LSC Repair Upper Plaza

Project Number – 21-164329

ADDENDUM 2

QUESTIONS/RESPONSES:

SA-102

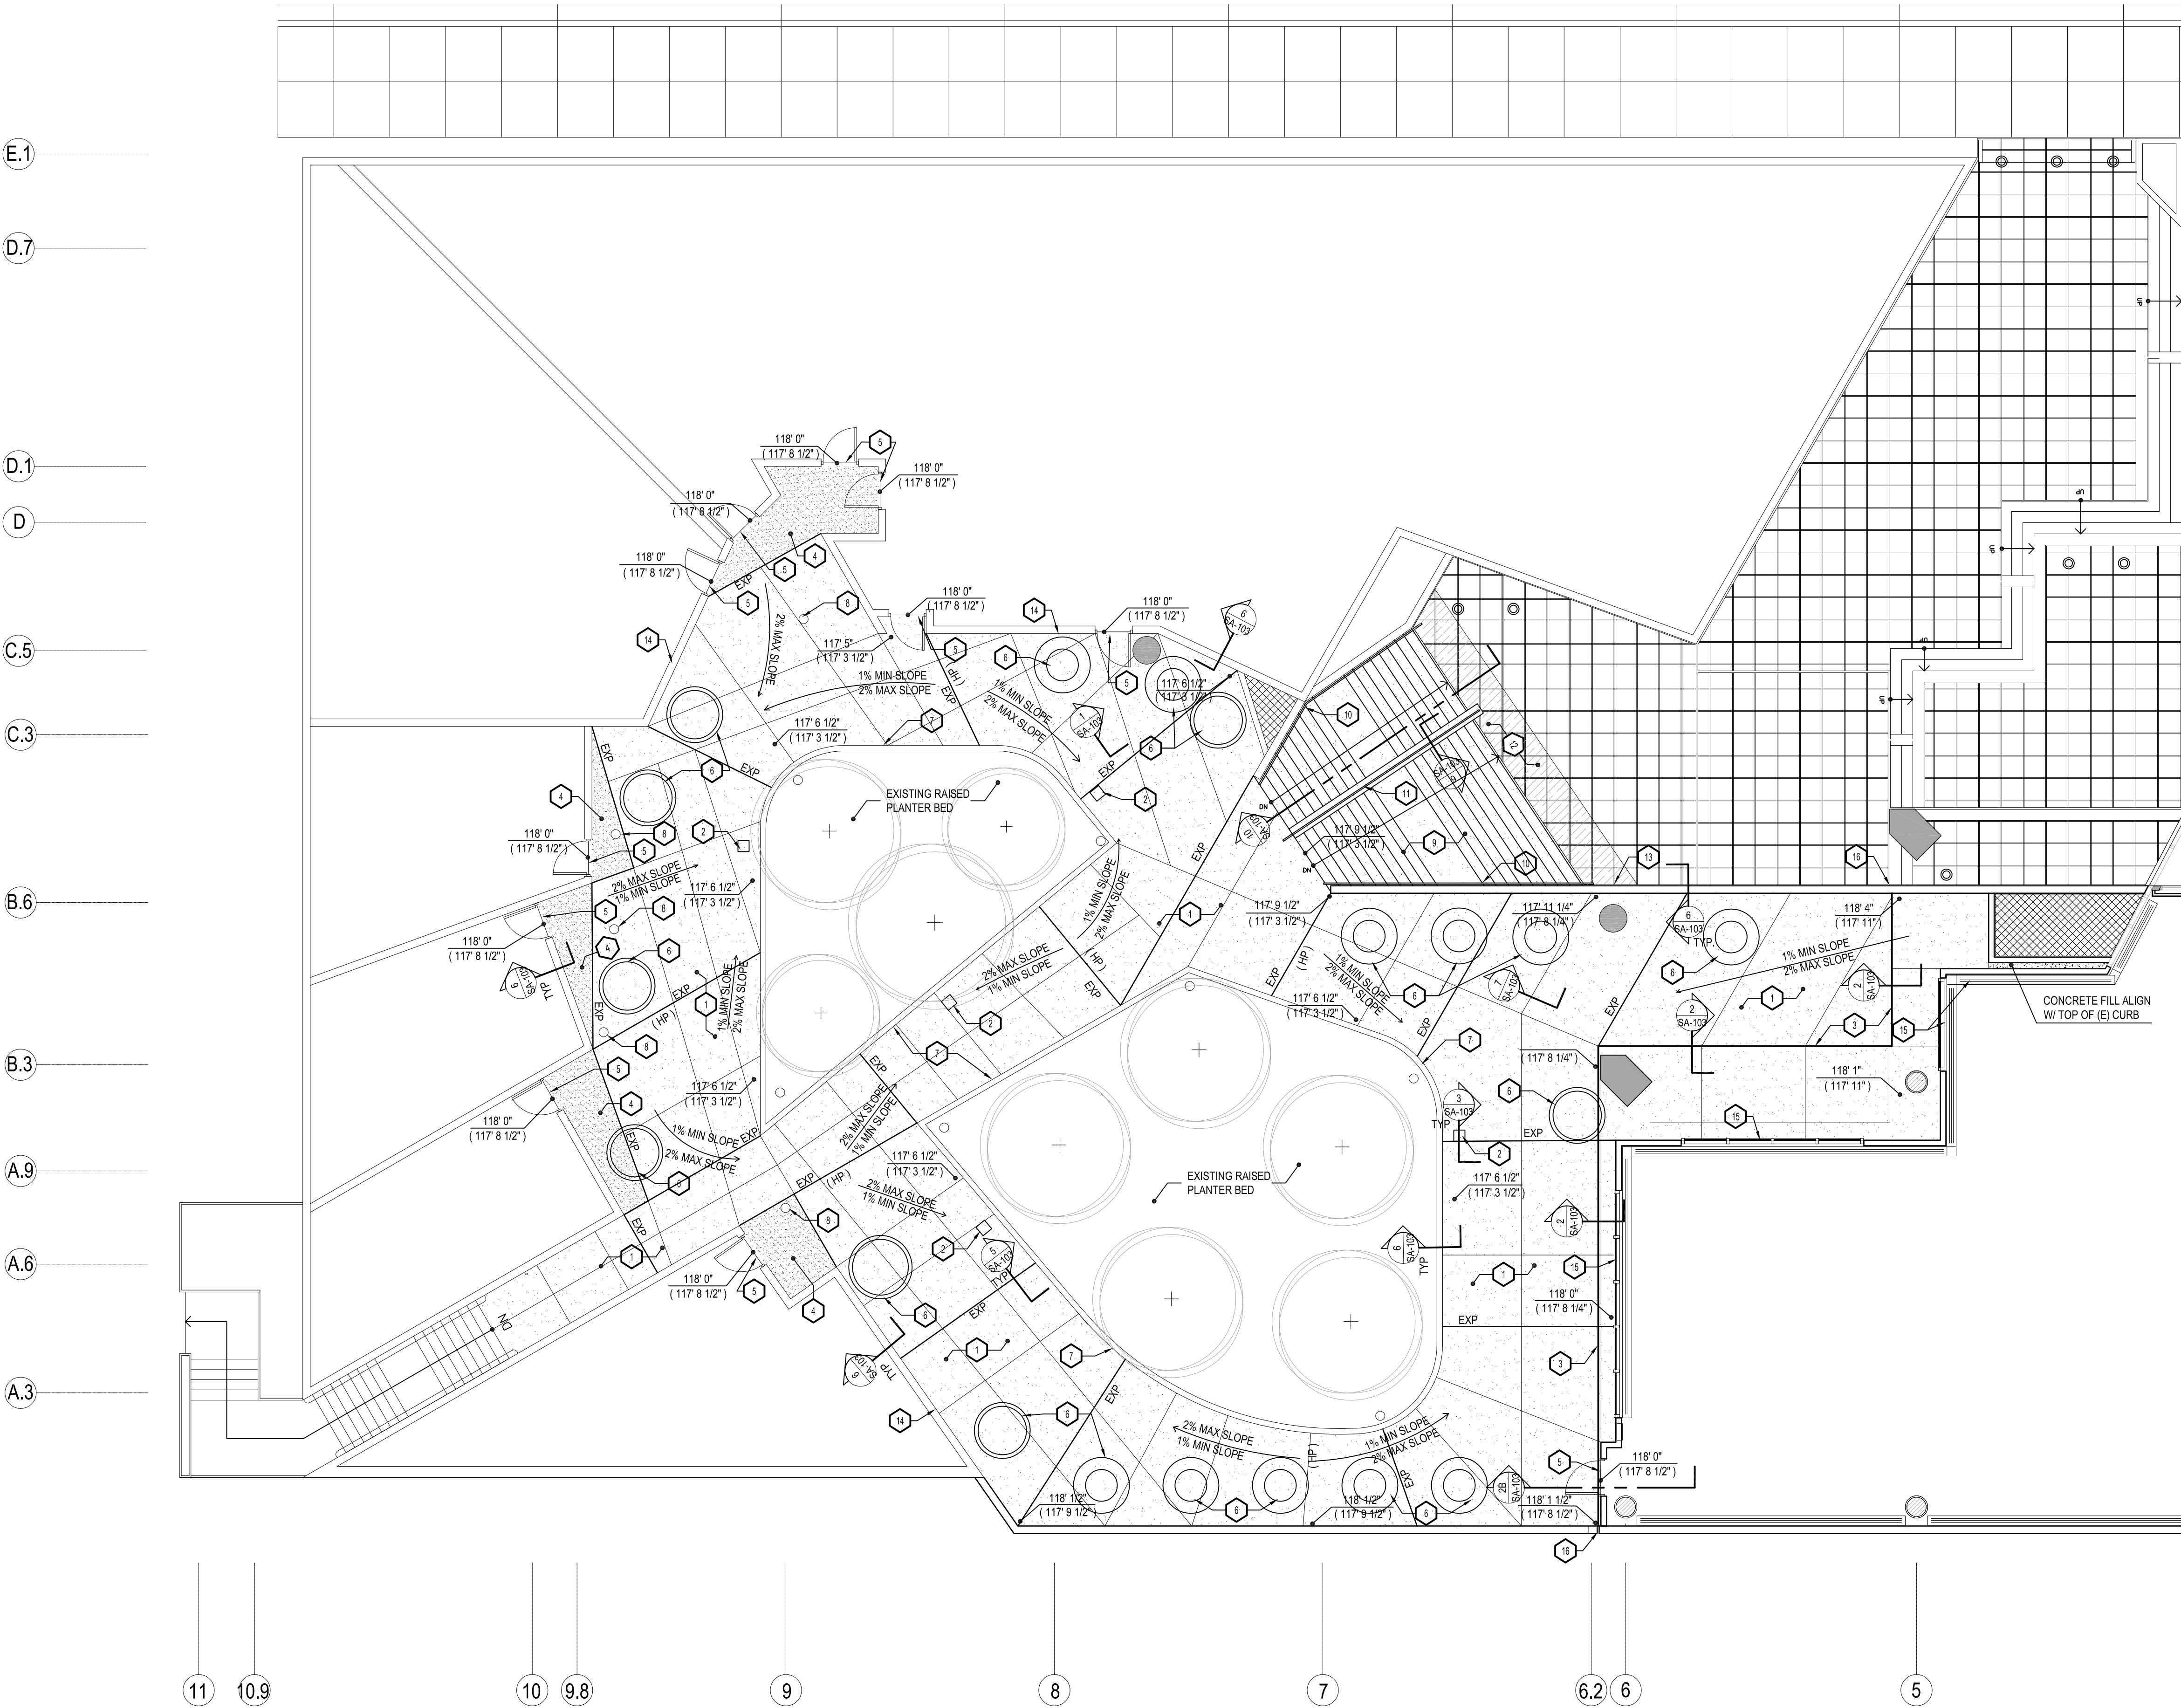
17	SA-102	CD	14-Jun-23	Kiewit	Drawing SA-102, can the control joint pattern be adjusted/alterd to simplify the pattern?	No, control joints are aligned with unique site features. Contractor can submit alternate pattern for consideration prior to bid completion.	21-Jun-23	Zoe Peters - AW	
18	SA-102	CD	14-Jun-23	Kiewit	Drawing SA-102, an area drain is shown adjacent to a ½" expansion joint. Can you please confirm this joint may be moved, to allow for concrete coverage around entire drain body?	Drain locations are existing locations to be reused. Contractor can work with design team to adjust EJ locations as needed for this purpose.	21-Jun-23	Zoe Peters - AW	
19		CD	14-Jun-23	Kiewit	Is a water test of the waterproofing system required of the entire plaza prior to placement of concrete? If so, what is the minimum area for testing?	This would be a means and methods for the contractor but it would be best practice for the contractor to do an entire plaza water test prior to placement of concrete.	21-Jun-23	Zoe Peters - AW
